Enclosure 1.0

ITS Section 3.1 REACTIVITY CONTROL SYSTEMS

SUMMARY DESCRIPTION of ITS/BASES CHANGES ITS SECTION 3.1 - REACTIVITY CONTROL SYSTEMS

BROWNS FERRY NUCLEAR PLANT - IMPROVED TECHNICAL SPECIFICATIONS
SECTION 3.1
REVISION 2
LIST OF REVISED PAGES

SR 3.1.2.1

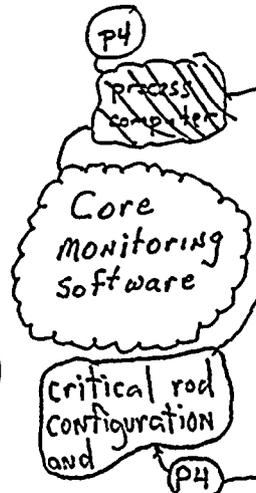
actual critical rod configuration and the expected configuration

Verifying the reactivity difference between the ~~monitored and predicted rod density~~ is within the limits of the LCO provides added assurance that plant operation is maintained within the assumptions of the DBA and transient analyses. The Core Monitoring System calculates the rod density for the reactor conditions obtained from plant instrumentation. A comparison of the monitored rod density to the predicted rod density at the same cycle exposure is used to calculate the reactivity difference. The comparison is required when the core reactivity has potentially changed by a significant amount. This may occur following a refueling in which new fuel assemblies are loaded, fuel assemblies are shuffled within the core, or control rods are replaced or shuffled. Control rod replacement refers to the decoupling and removal of a control rod from a core location, and subsequent replacement with a new control rod or a control

L. APRM Setpoints

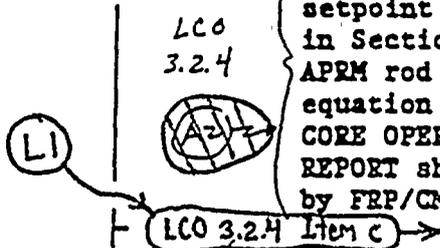
SR 3.2.4.1
FRP/CMFLPD shall be determined daily when the reactor is $\geq 25\%$ of rated thermal power.

(M1) Add proposed 1st Frequency of SR 3.2.4.1

4.5.APEM Setpoints

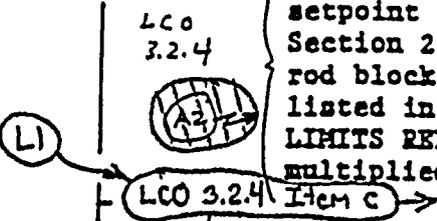
SR 3.2.4.1
FRP/CMFLPD shall be determined daily when the reactor is $\geq 25\%$ of rated thermal power.

(A2)

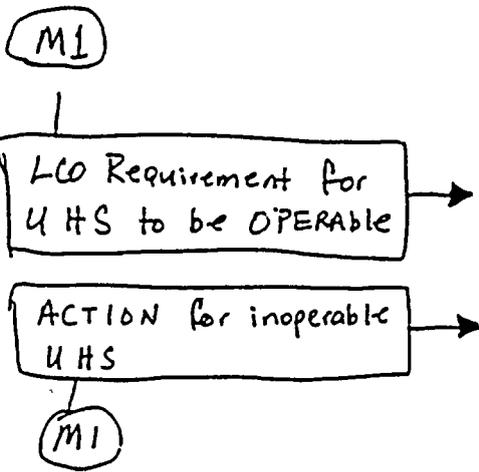
See Justification for Changes for BFN ISTS 3.7.1

~~4.5.G RHR Service Water and Emergency Equipment Cooling Water Systems (EECWS)~~

LCO 3.7.2

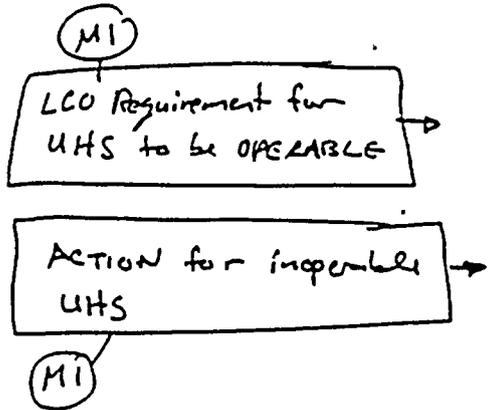
(A3)

ACTION A&B

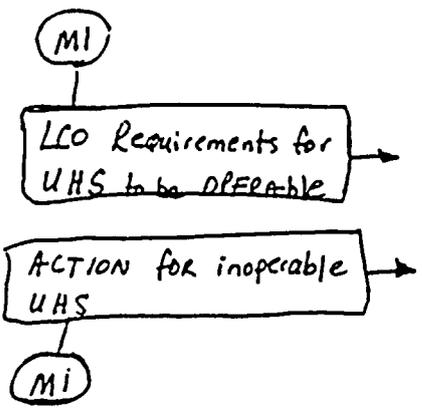
See Justification for Changes for BFN ISTS 3.7.1

~~4.5.6 RHR Service Water and Emergency Equipment Cooling Water Systems (EECWS)~~
